**Flood Control Project Maintenance
Levee Inspections**
LMA District Cover Sheet
Spring 2018 Levee Inspection Results

Sutter Maintenance Yard Wadsworth Canal

Levee Inspection Report By Mile - Spring 2018

Photo 2 of 3 : UCIP_SP_2018_51500_64717.jpg

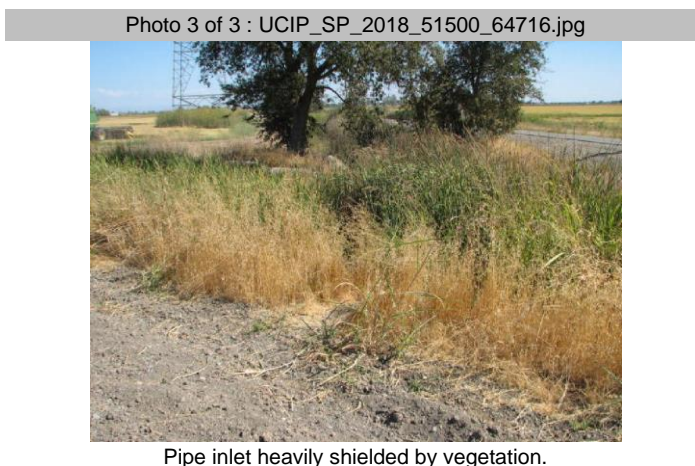
LM Start	3.04	Rating **	M	Issue No.	111
LM End	3.04	Issue Type +	Ma	Location *	
Category	Supplemental			GPS Latitude/Longitude	
				Start	End
Item	DWR UCIP LMA Responsibility			39.149549 °	39.149549 °
				-121.736408 °	-121.736408 °
DWR ID

FS_ID:51500
DS_ID:17065
EP_NO: 7209
Repair Type: Non-Urgent
Crossing Status: Found
UCIP Comments: 4/10/2017 Ws pipe end is in good condition. LS pipe end is still deformed and vegetated. (DWR Sutter Yard - AFreitag)10/12/2016 LS inlet is still deformed and being overgrown by vegetation.(DWR Sutter Yard - afreitag)4/19/2016 Crossing appears to be in good condition.5/12/2015 LS inlet still deformed a little but does not affect the crossing function.11/18/2014 Same as last inspection.5/13/2014 Same as last inspection.10/29/2013 Same as last inspection.5/16/2013 Pipe intake on LS appears to be bent and damaged but that does not appear to be affecting water flow or channel bank.
FIELD_STRUCT_DESC: 36-inch corrugated metal drainage pipe (permit records indicate 30-inch, USACE O&M pipe replaced with new 30-inch pipe) through the levee, 9 feet below the crown. Flap gate located on the waterside (WS) end. (Original O&M manual crossing was replaced under Permit No. 7209, 1970 - Department of Water Resources [DWR]) [Additional Reference(s): DWR Levee Log, 2005. USACE Sacramento O&M Manual 135, May 1953, (Station 160+25)].

Photo 3 of 3 : UCIP_SP_2018_51515_64742.jpg

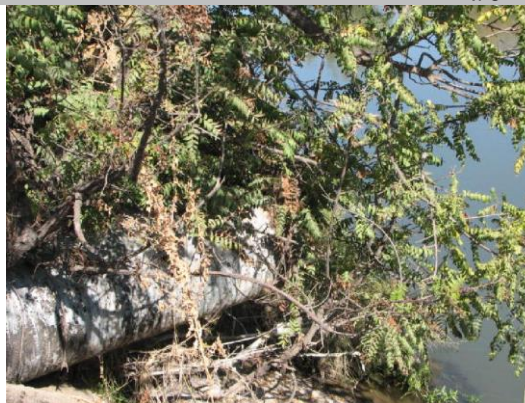
LM Start	3.00	Rating **	M	Issue No.	26 (cont)	
LM End	3.00	Issue Type +	Ma	Location *		
Category	Supplemental			GPS Latitude/Longitude		
				Start	End	
Item	DWR UCIP LMA Responsibility			39.149561 °	39.149561 °	
				-121.737080 °	-121.737080 °	
DWR ID

Comment Code						
Inspector Comment						
FS_ID:51515 DS_ID:17077 EP_NO: 7209 Repair Type: Non-Urgent Crossing Status: Found UCIP Comments: 4/10/2017 Tree still present and a problem at the WS pipe outlet. LS inlet is still vegetated. (DWR Sutter Yard-AFreitag)10/12/2016 Tree at the WS pipe end is still an issue and needs to be cut away. LS inlet is also being overgrown with vegetation.(DWR Sutter Yard - afreitag)4/19/2016 Tree at WS pipe end needs to be trimmed back and/or removed. 5/12/2015 Tree growing near WS pipe end is getting too big and will affect the crossing. It needs to be cut back or removed.11/18/2014 Same as last inspection.5/13/2014 Same as last inspection.10/29/2013 Same as last inspection.5/16/2013 Same as last inspection. FIELD_STRUCT_DESC: 36-inch corrugated metal drainage pipe (permit records indicate 30-inch pipe, O&M pipe replaced with new 30-inch pipe) through the levee, 14 feet below the crown. Flap gate located on the waterside (WS) end. (Original O&M manual crossing was replaced under Permit No. 7209, 1970 - Department of Water Resources [DWR]). [Additional Reference(s): DWR Levee Log, 2005. USACE Sacramento O&M Manual 135, May 1953, (Station 158+35)]. FS Date: 4/12/2017 10:16:27 AM
